ENDL T E X A S

Date: 18 April 2000
 To: T10 Technical Committee
 From: Ralph O. Weber
 Subject: SAM-2 Byte Count That's Really Buffer Size

Figure 29 — Model for buffered data transfers

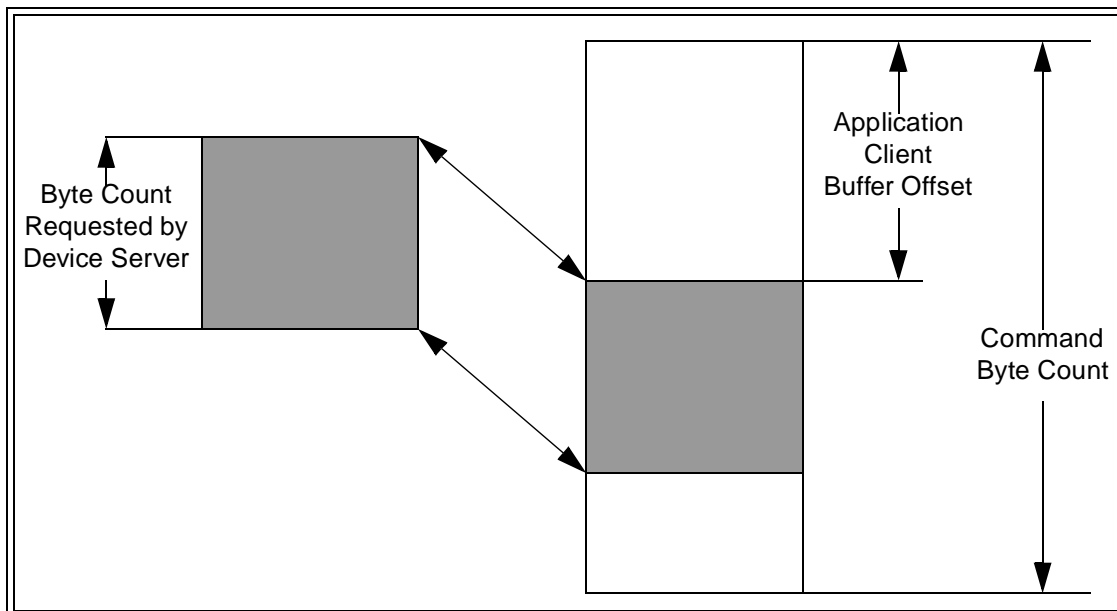
Clearly, this usage of 'command byte count' is the application client data buffer size and exactly the entity that FCP-2 wants to reference.

The working group agreed that SAM-2 should be changed to use the 'command byte count' concept shown in the figure, as opposed to the written definition. This proposal contains a collection of specific SAM-2 changes to meet the working group request.

Change 4: In figure 29 (the figure reproduced above) after the second paragraph of 5.3.1 (SAM-2 rev 13 pdf page 70)

Replace 'Command Byte Count' with 'Application Client Buffer Size'
